HISTORIC AND DESIGN REVIEW COMMISSION

HDRC CASE NO: 2017-619 ADDRESS: 204 NOLAN

TYPE OF WORK: Gutter installation on front porch

RE: Dullnig Structure Stabilization Scope of Work 204 Nolan Street San Antonio, TX 78202

2 OF 9

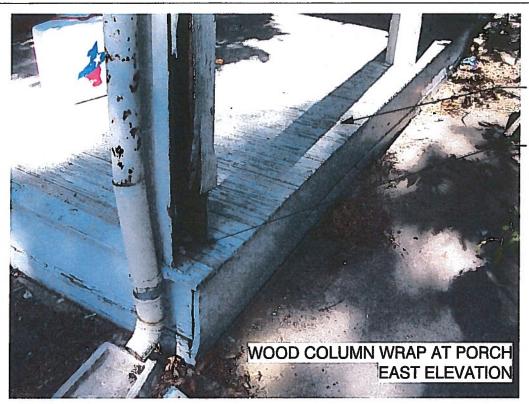
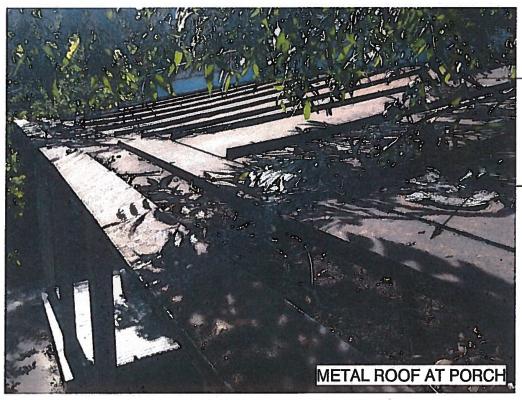
The applicant is requesting a Certificate of Appropriateness for approval to removal an original, integral porch gutter and replace with a surface mounted gutter and downspouts. This modification includes the removal of the existing, decorative fascia and replacement with a flat profiled fascia.

and Alterations 7. notes that porches and porch elements are to be repaired to match the existing. The removal of the integral gutter and decorative fascia would result in the removal of a character defining feature and is not consistent with the Guidelines. Staff recommends that the existing, integral gutter as well as decorative parapet remain as original constructed. Repairs are eligible for administrative approval.

REPLACE BUILT-IN GUTTER WITH HALF ROUND METAL GUTTER AND ROUND DOWNSPOUT

Staff does not recommend approval based on finding b. If the HDRC finds that circumstances such as maintenance issues warrant approval to remove the integral gutter, then staff finds the simple, half-round gutter to be an acceptable alternative solution.
